To:	Mark Valeriotte (JDS) Greg Blaylock (JDS)	Date:	January 24, 2011
cc:	Maritz Rykaart (SRK)	From:	Lowell Wade (SRK)
Subject:	Doris North – North Dam Fillet Construction	Project #:	1CH008.033

Request for Information

To:	Mark Valeriotte, Greg Blaylock	Date:	February 15, 2011
cc:		From:	Lowell Wade, Maritz Rykaart
Subject:	Hope Bay Project – North Dam Additional Key Trench Excavation in Peat Zone	Project #:	1CH008.033

To:	Mark Valeriote	Date:	April 15, 2011
Company:	Hope Bay Mining Limited	From:	Maritz Rykaart, Lowell Wade
Copy to:	Greg Blaylock, Kevin Mather	Project #:	1CH008.033.0213
Subject:	North Dam Close-out Plan for April/May 2011 - FINAL

HOPE BAY MINING LIMITED		North Dam		
			Contingency Close-out Plan B		
Job No: 1CH008.033.0213	Doris North Project		Date: April 15, 2011	Approved: EMR	Figure: 3
Filename: Close-out Plan Drawings.pptx

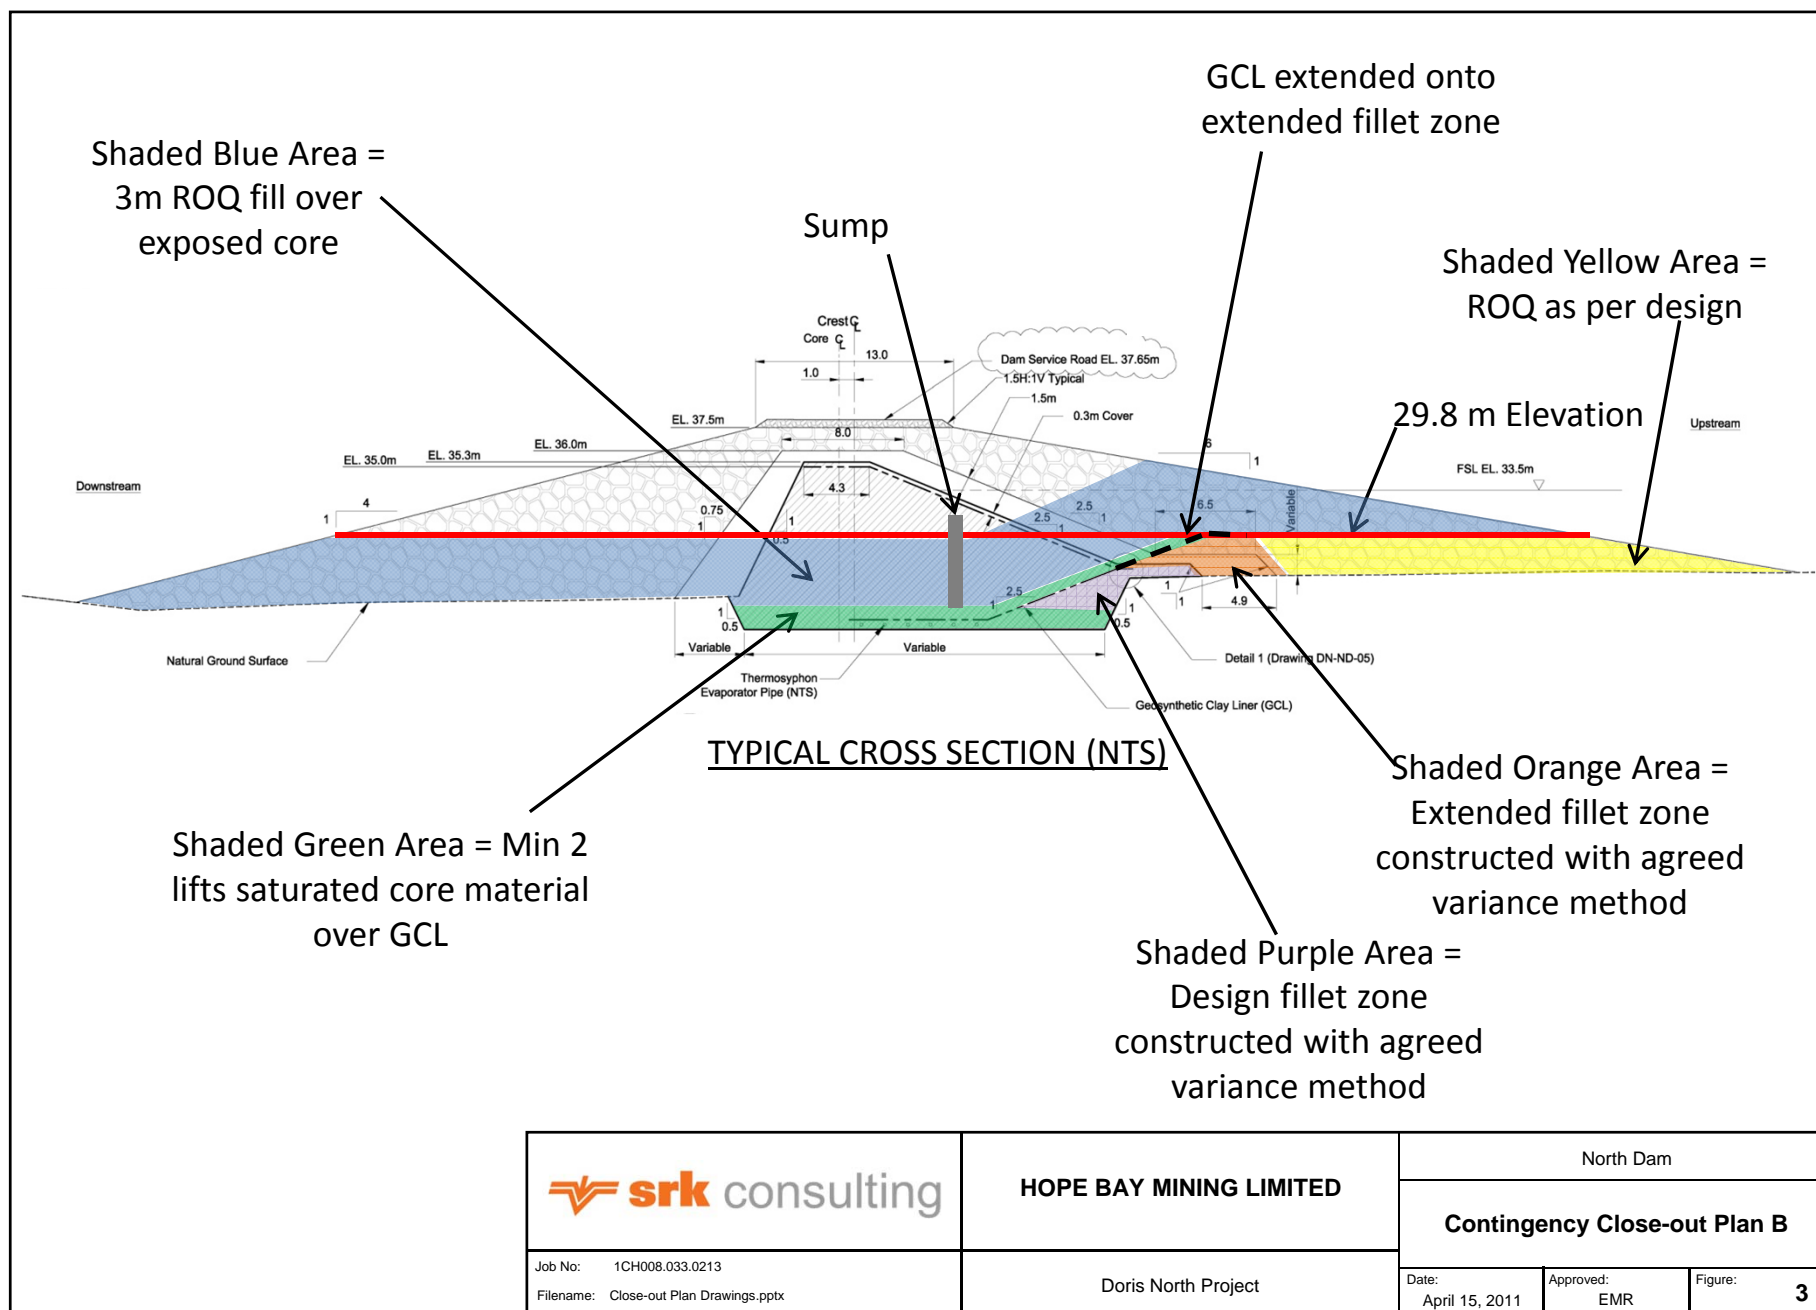
The following elements describe this contingency close-out plan, as illustrated on Figure 3:

- Rather than terminating the fillet zone at the design elevation for the lower GCL, extend the fillet zone to elevation of 29.8 m where appropriate. This additional fillet will be constructed in accordance with the approved variance for fillet construction, and will continue rising at a slope of 2.5:1.

- The final crest width of the extended fillet zone, at elevation 29.8 m, must be at least 3.5 m wide. The upstream slope of the extended fillet can be 1:1 down to original ground.

- Cover the extended fillet with GCL by extending the lower GCL coming from the key trench. Terminate the GCL 1 m beyond the crest of the 29.8 m elevation on the horizontal surface.

SRK recommends that contingency close-out Plan B be implemented. Specific details on placement of the single bead ground temperature cables, placement of the sump and extent of the ROQ cover,
